SERVICE BULLETIN

ENGINE FUEL AND CONTROL — FUEL DIVERTER AND RETURN VALVE — REPLACEMENT OF
THE FUEL DIVERTER AND RETURN VALVE TO DECREASE SERVICE INTERRUPTIONS

V2500 Series 73-0247

V2500-ENG-73-0247

LOCATION OF THE FDRV FOR V2500-A1 ENGINE MODELS
73-13-42
FIGURE 1

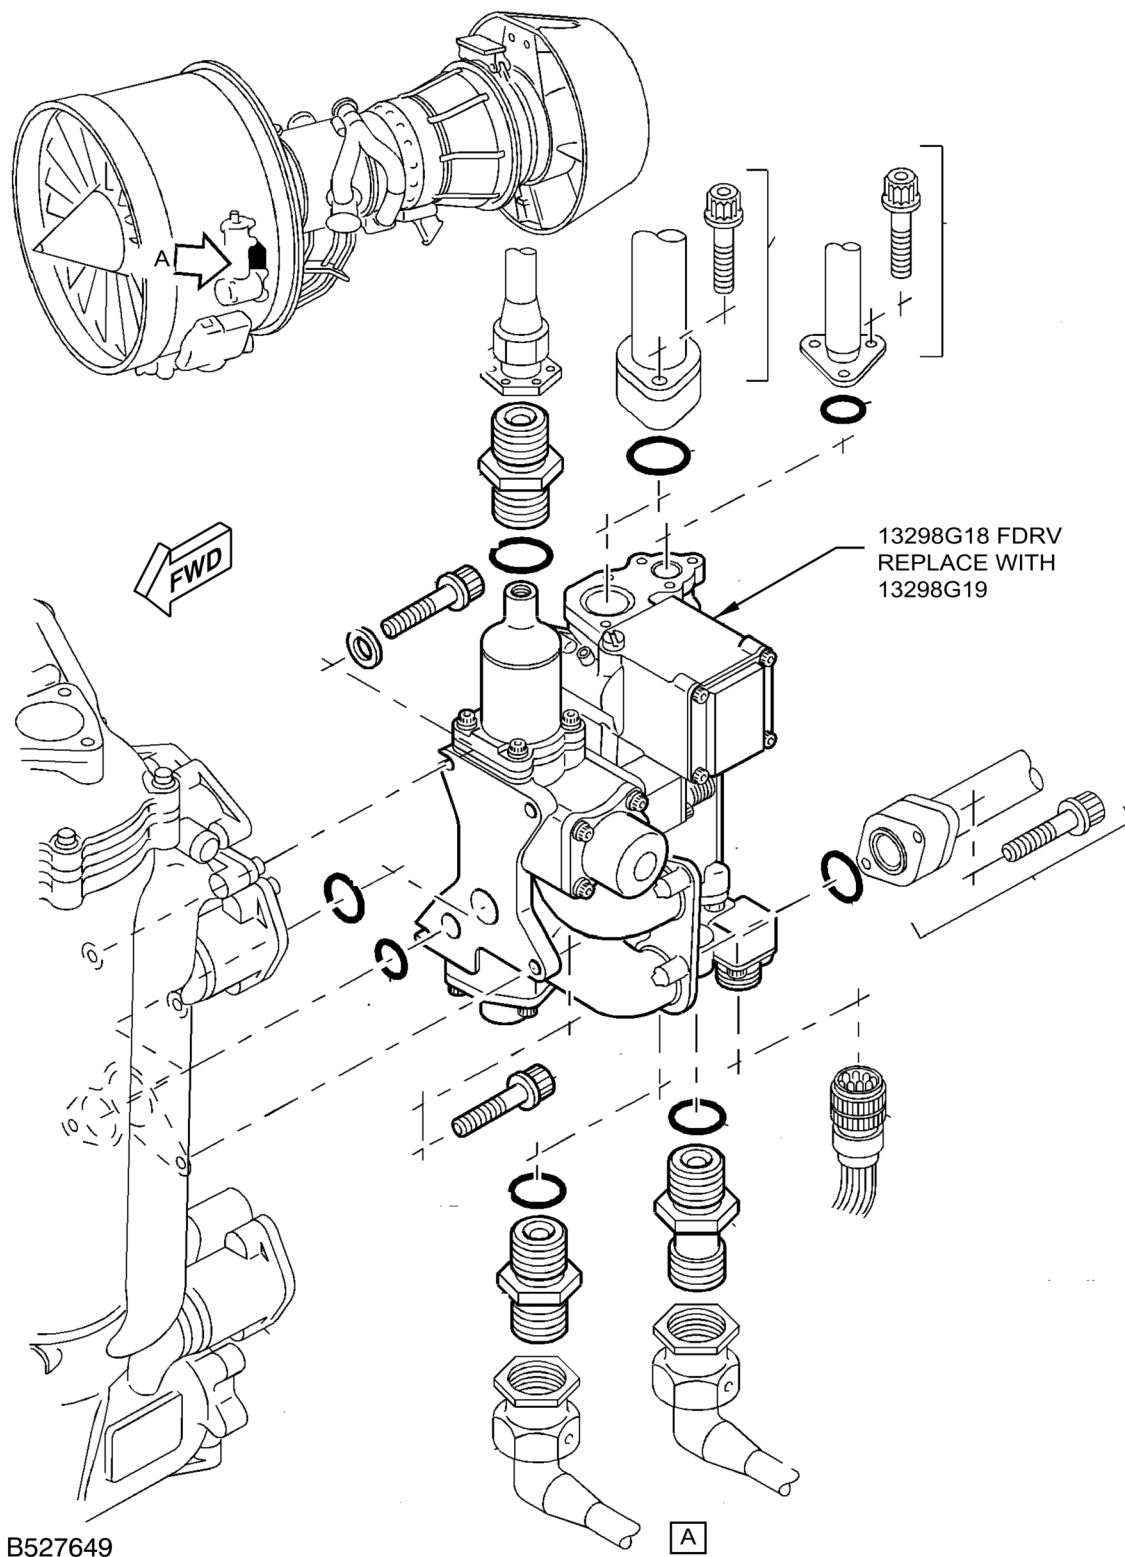
1. Replace the FDRV, PN 13298G18 with PN 13298G19. See Figure 1.
 - A. Remove the FDRV, PN 13298G18 as specified in Reference 6, Aircraft Maintenance Manual, Task 73-13-42-000-010-A.
 - B. Install the new FDRV, PN 13298G19 as specified in Reference 6, Aircraft Maintenance Manual, Task 73-13-42-400-010-A.
2. Return the removed FDRV, PN 13298G18 to the vendor listed in the Vendor Services or Special Components/Materials.
3. Recording Instructions
 - A. A record of accomplishment is required.

1. Replace the FDRV, PN 13298G18 with PN 13298G19. See Figure 1.
2. Return the removed FDRV, PN 13298G18 to the vendor listed in the Vendor Services or Special Components/Materials.
3. Recording Instructions
 - A. A record of accomplishment is required.

LOCATION OF THE FDRV FOR V2500-A5 ENGINE MODELS
73-13-42
FIGURE 2

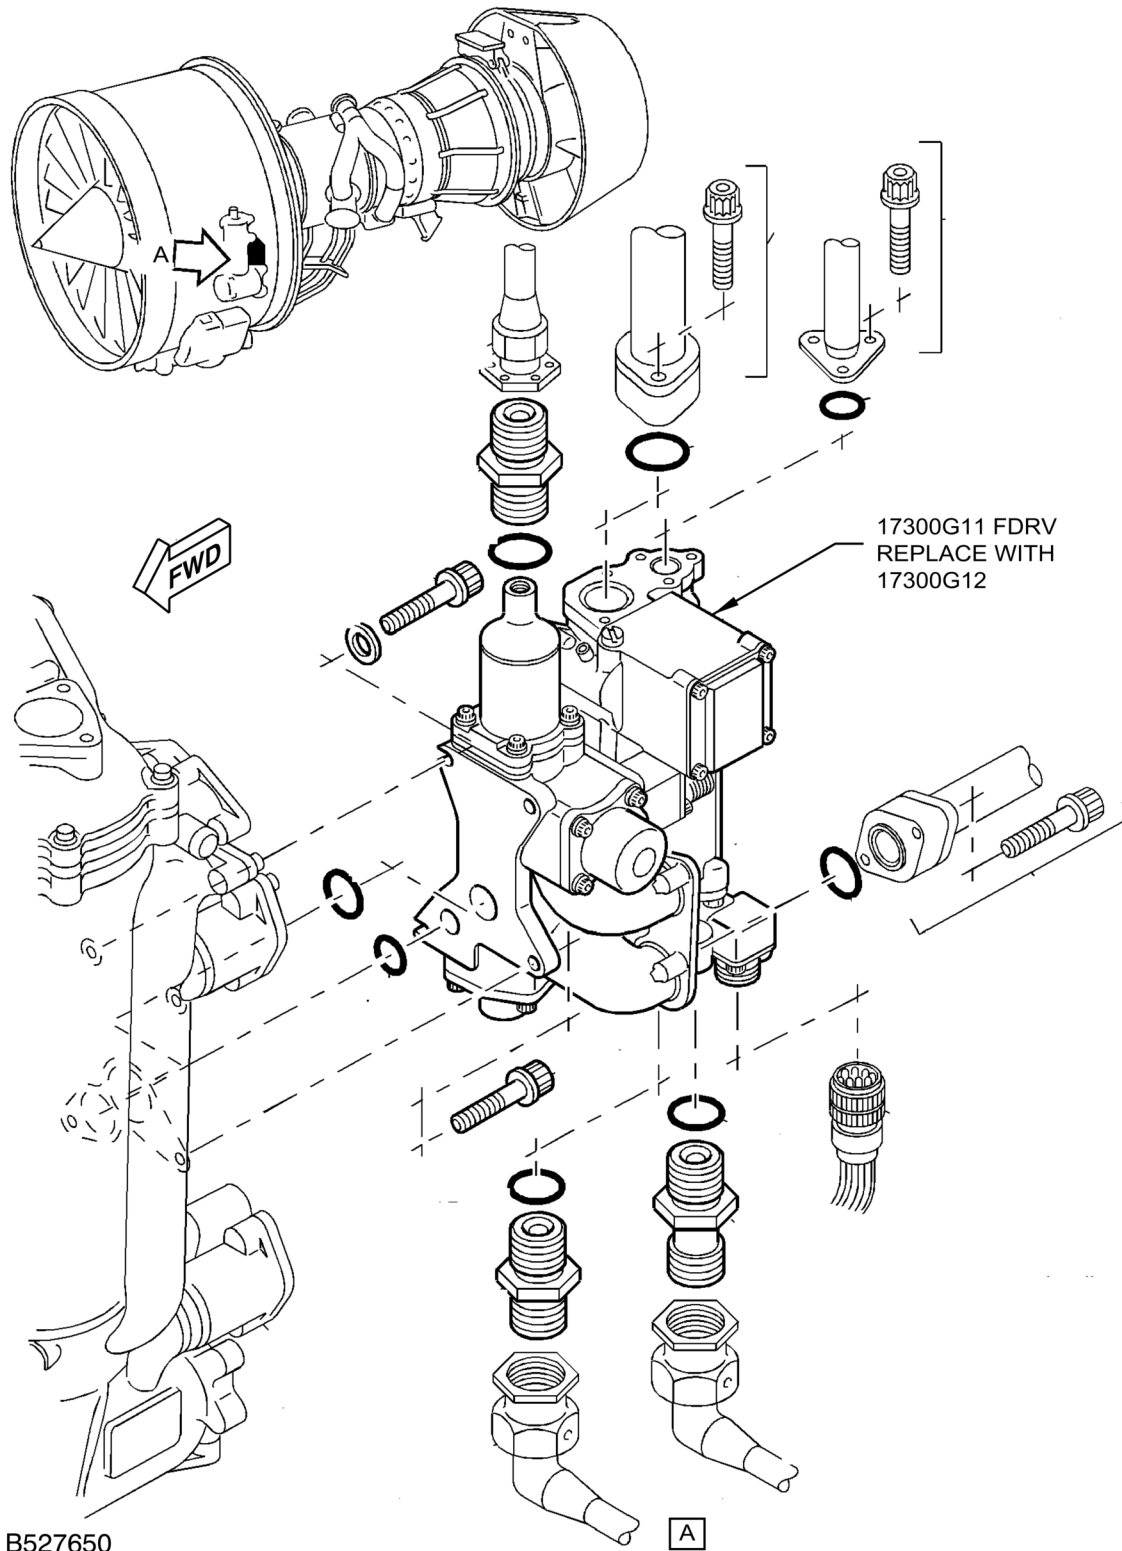
1. Replace the FDRV, PN 17300G11 by the procedure that follows. See Figure 2.
 - A. Remove the FDRV, PN 17300G11 as specified in Reference 6, Aircraft Maintenance Manual, Task 73-13-42-000-010-A.
 - B. Install the new FDRV, PN 17300G12 as specified in Reference 6, Aircraft Maintenance Manual, Task 73-13-42-400-010-A.
2. Return the removed FDRV, PN 17300G11 to the vendor listed in the Vendor Services or Special Components/Materials.
3. Recording Instructions
 - A. A record of accomplishment is required.

1. Replace the FDRV, PN 17300G11 with 17300G12. See Figure 2.
2. Return the removed FDRV, PN 17300G11 to the vendor listed in the Vendor Services or Special Components/Materials.

LOCATION OF THE FDRV FOR V2500-D5 ENGINE MODELS
73-13-42
FIGURE 3

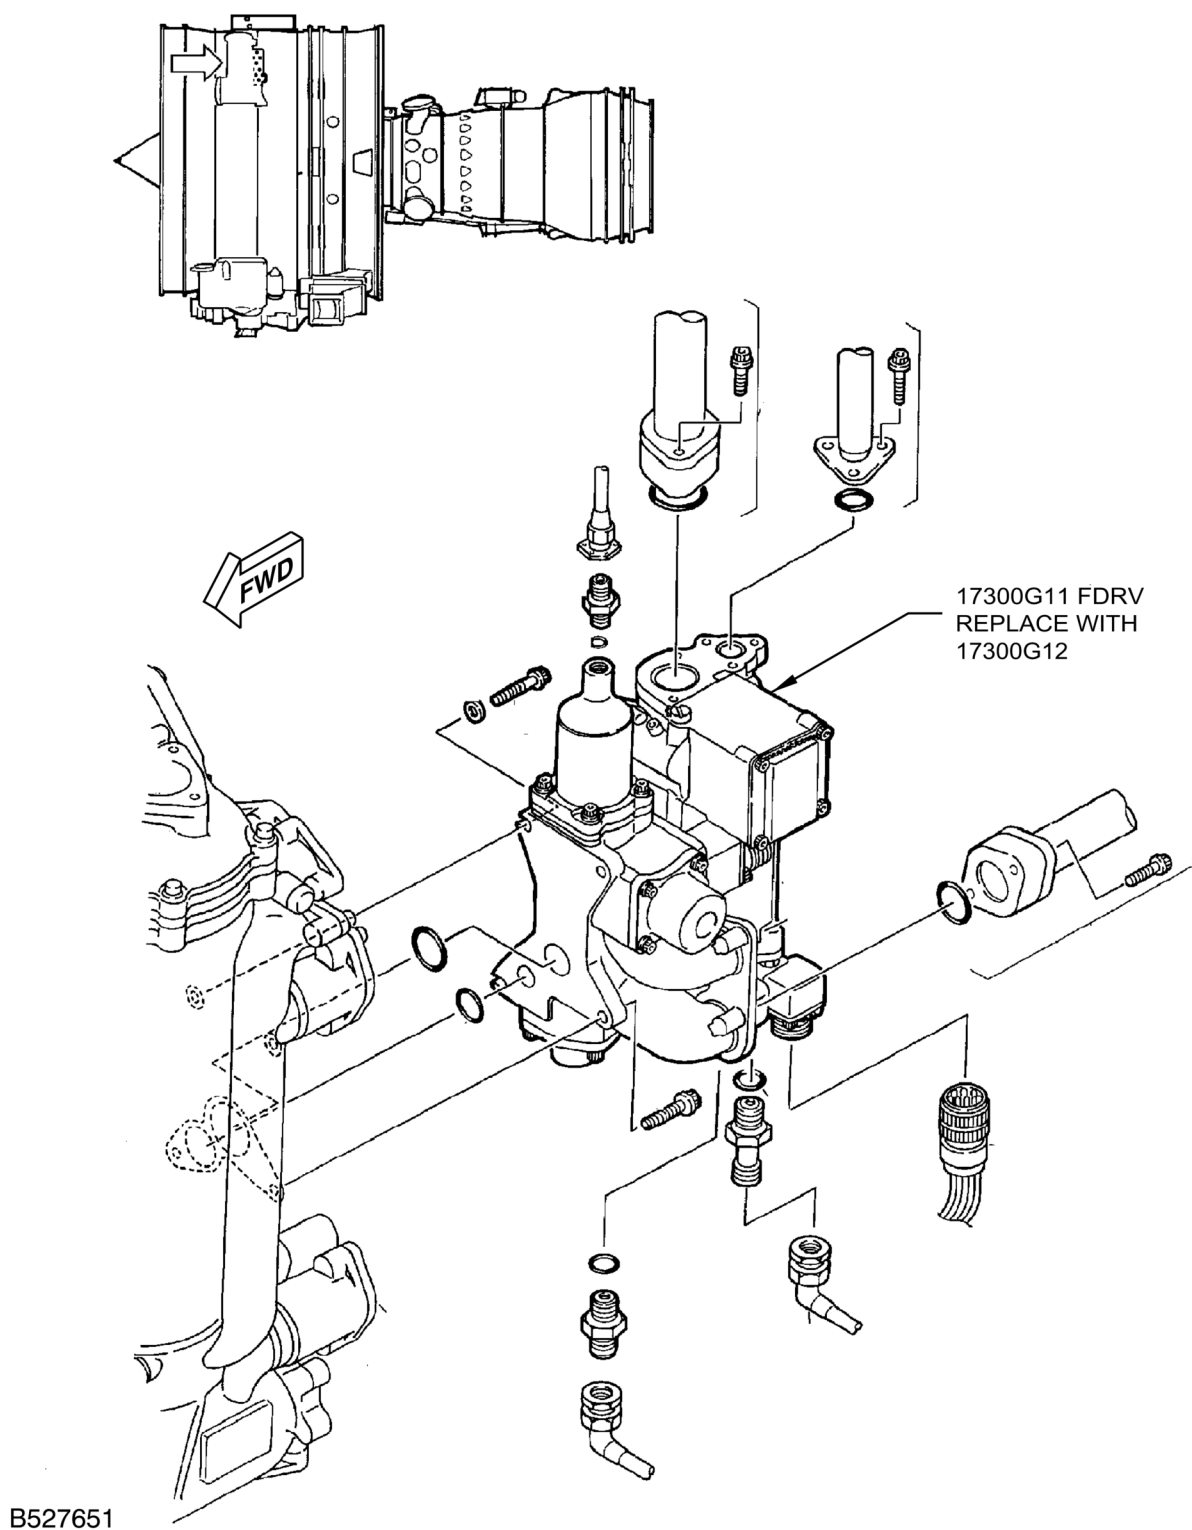
1. Replace the FDRV, PN 17300G11 with 17300G12. See Figure 3.
 - A. Remove the FDRV, PN 17300G11 as specified in Reference 7, Aircraft Maintenance Manual, Task 73-13-42-020-801.
 - B. Install the new FDRV, PN 17300G12 as specified in Reference 7, Aircraft Maintenance Manual, Task 73-13-42-420-801.

1. Replace the FDRV, PN 17300G11 with 17300G12. See Figure 3.
2. Return the removed FDRV, PN 17300G11 to the vendor listed in the Vendor Services or Special Components/Materials.
3. Recording Instructions
 - A. A record of accomplishment is required.
